MX0025A-01

Modification Recommended Service Note

InfiniiMax Ultra 25 GHz Probe Amp with AutoProbe 2 Interface

Figure 1.

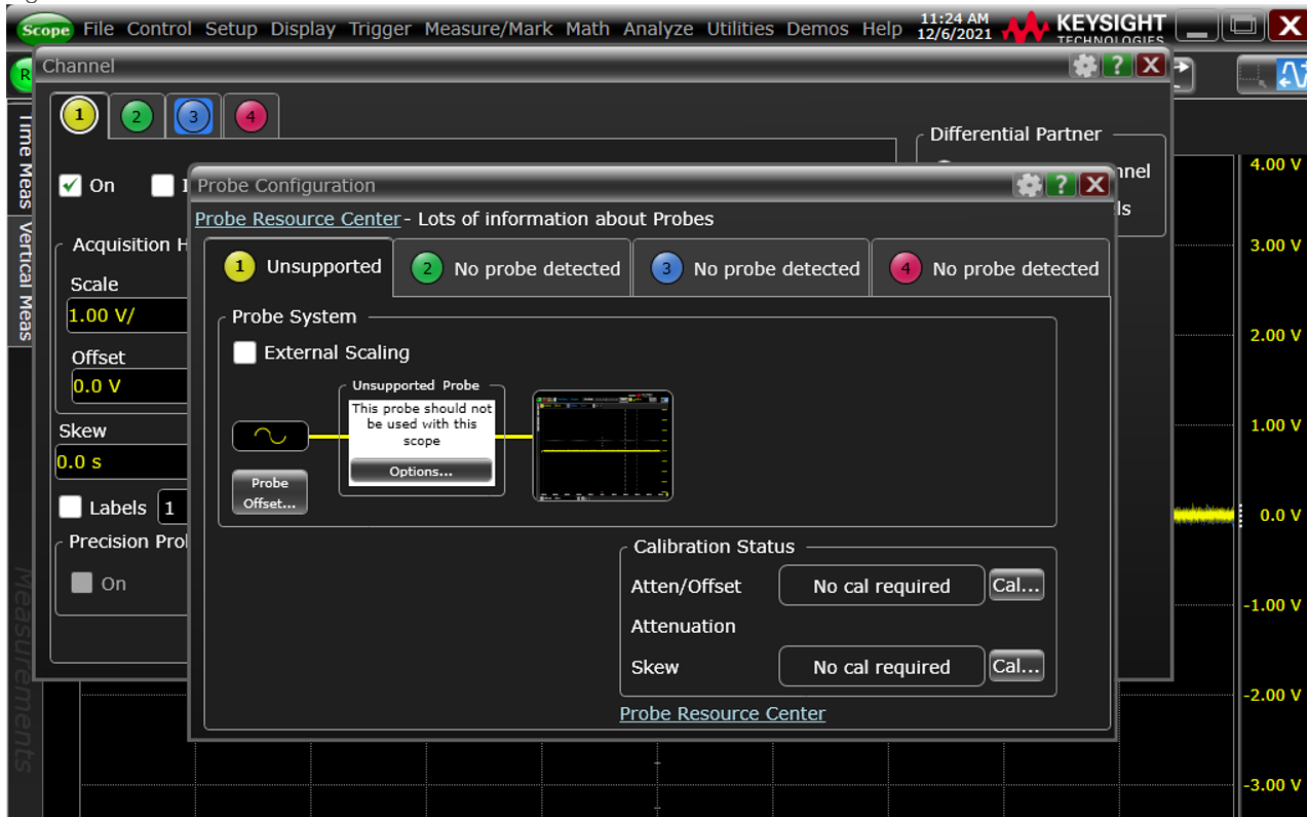
The early shipments of MX0025A probes have a quality concern that can cause probes to not be recognized when attached to the scope channel. Please see Figure 1.

- 1. Capacitor failure

Please return defective probe amplifier to service center for repair.
